Model: General RTB	Date: 4-Feb-03	No.: RGene013b
--------------------	----------------	----------------

RTB Reissue

Subject: Service remarks at installation		Prepared by: T. Itoh	
From: Technical Service Sec. Service Planning Dept.			
Classification:	<input type="checkbox"/> Troubleshooting	<input type="checkbox"/> Part information	<input type="checkbox"/> Action required
	<input type="checkbox"/> Mechanical	<input type="checkbox"/> Electrical	<input type="checkbox"/> Service manual revision
	<input type="checkbox"/> Paper path	<input type="checkbox"/> Transmit/receive	<input type="checkbox"/> Retrofit information
	<input checked="" type="checkbox"/> Other (Specification change)

Attaching position: Rear side view

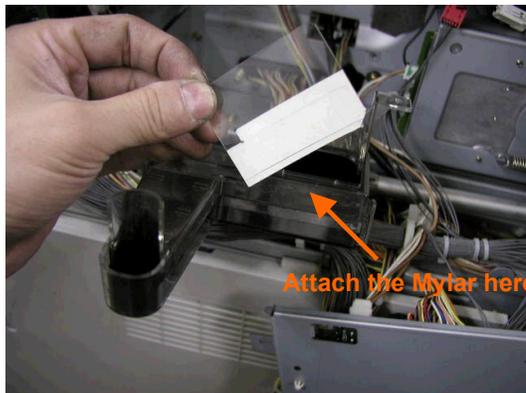
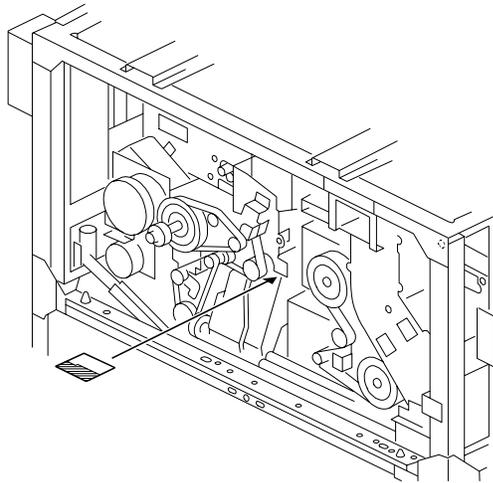
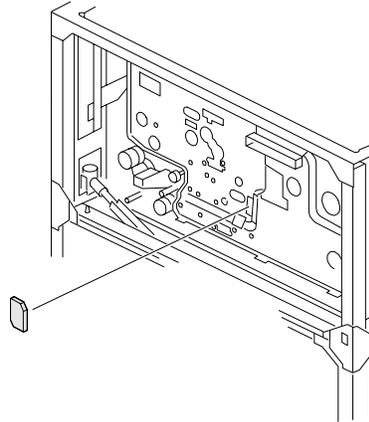
b) Attach the Mylar (B0703618) to the top of the toner recycling case as shown below. This will prevent toner scattering at the connection between the transfer unit toner collection pipe and recycling case.

Seal (B0703619)

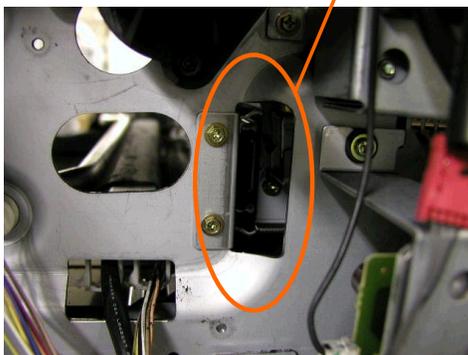
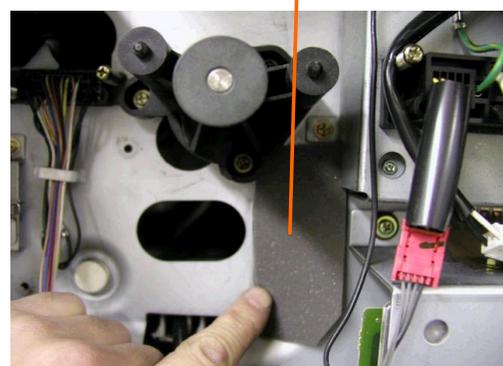
- c) Attach the new seal (B0703619) as shown below to the opening in the rear side plate. This will prevent toner scattering in the fusing and duplex areas.

Cover this opening with the seal

- P/N: B0703364 (Shield: Bracket Chuck)

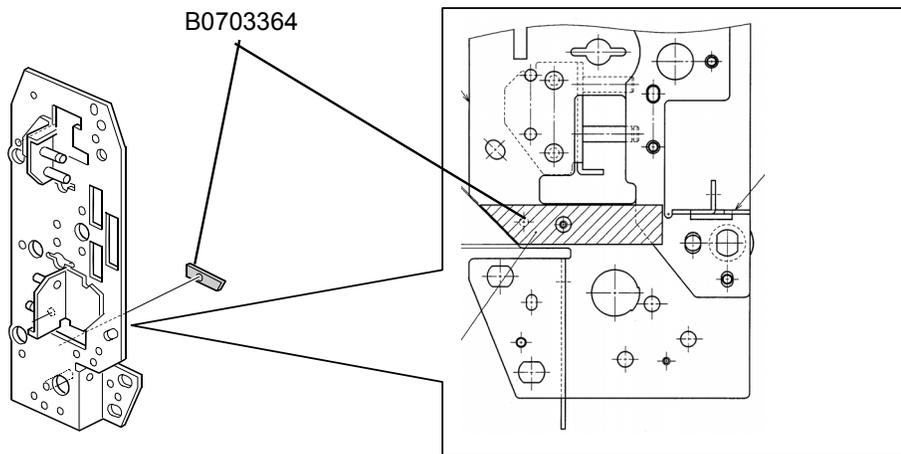
2. A seal has been added to the toner bank base plate, preventing toner from scattering out of this area.

- Attachment position: Refer to Parts Catalog, pg. 78

Side view:

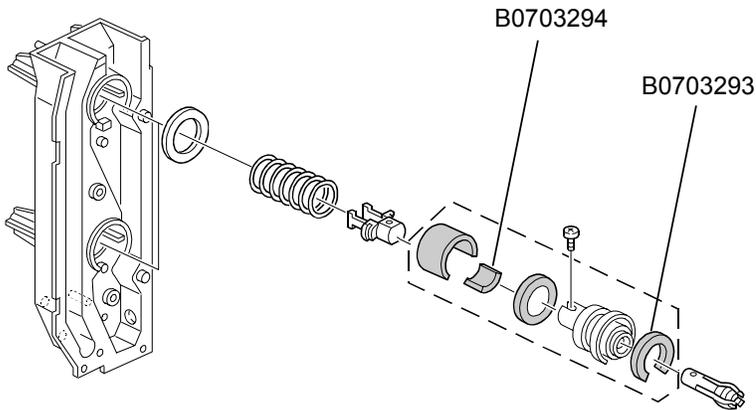
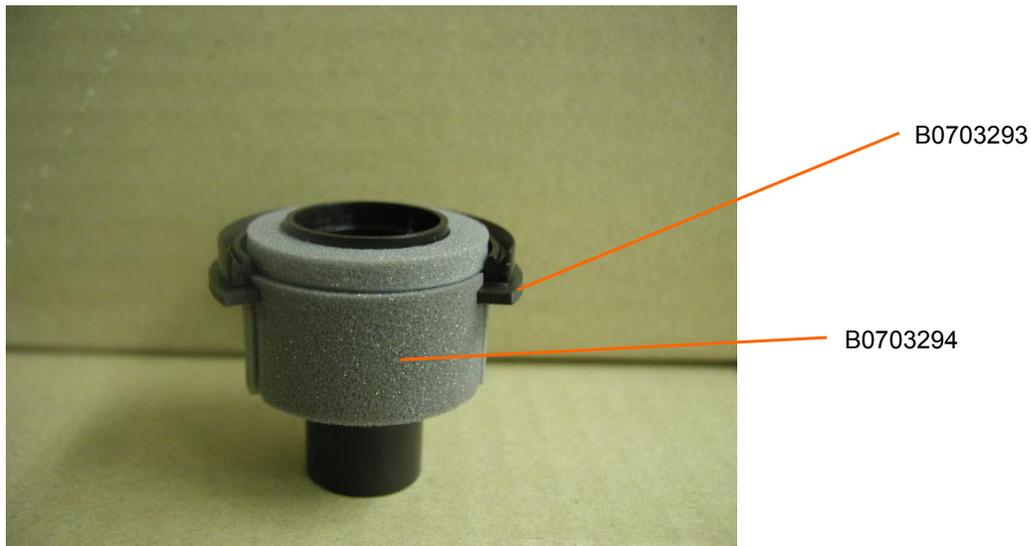
Two kinds of the shields have been added to ensure toner does not leak out from the toner bottle.

- P/N: B0703293 (Shield Slider), B0703294 (Shield Slider Short)
- Attachment position:

Controller Box Positioning Bracket

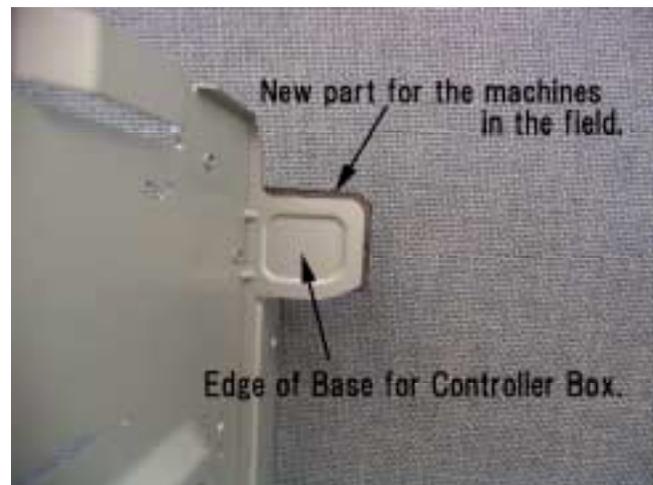
In order to further ensure working safety, a protective cover has been added to the positioning bracket on the controller box (see the photo on the next page).

A protective cover will be added to the entire area surrounding the bracket from the end of January 2004 production.

- 1) C2e Drum P/N: **B0709510**
- 2) Lot No. on the drum flange: **L**XXXXXXXX

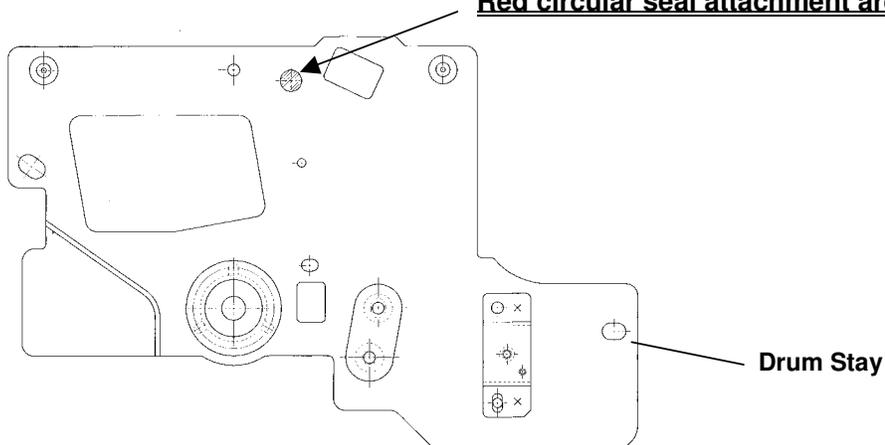
The OPC layer of the drum has been thickened, so the lifetime of the OPC drum has been increased. The following drum is fitted in C2e mainframes on the production line, but as service parts, it can also be used on C2 MIF (see point **5**) below).

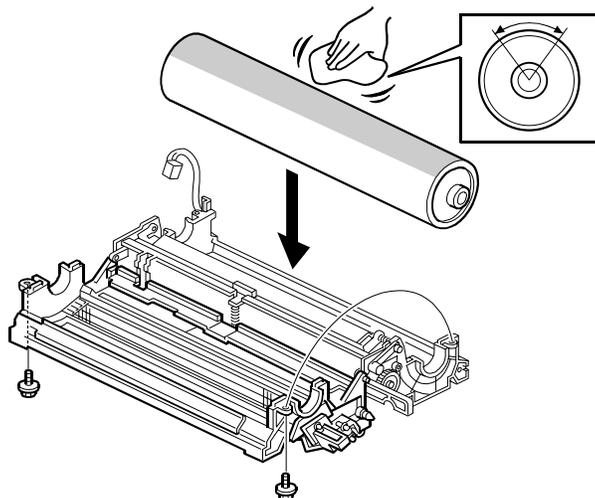
Since the smoothness of the new drum (without dichloromethane) is reduced, it is essential to **make sure to apply Drum Setting Powder (P/N: 54429101) to the drum surface as shown below before installing.**

Note: If the setting powder is not applied, the drum's cleaning blade may turn outward, causing a drum cleaning failure.

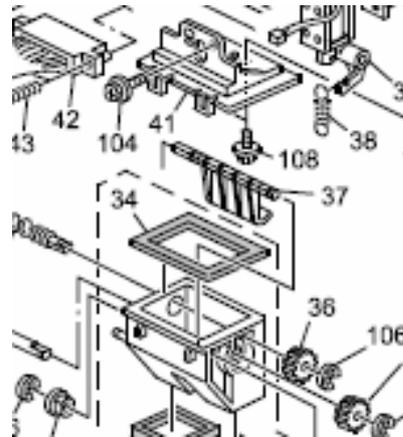
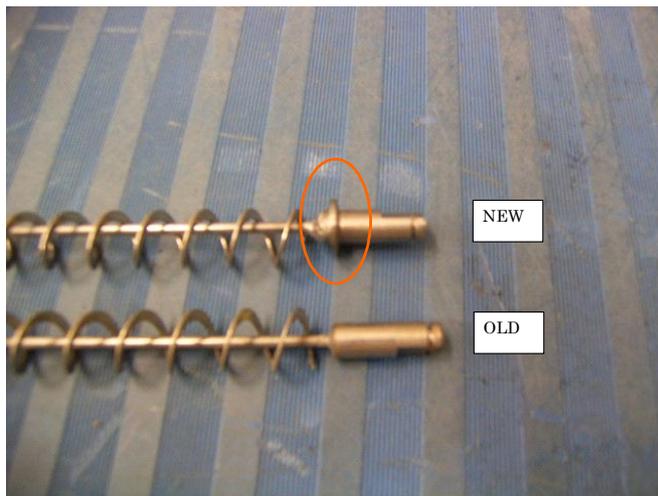
2. If you replace the toner transport coil (P/N A2943619), make sure to install the new coil and upper case (P/N B0703636; #41 below) **together as a set**.

Note: To ensure that the gears engage correctly, a spacer was added to the right edge of the coil from February 2004 production. There was no service P/N change, but all coils in stock at SPC are the new ones.
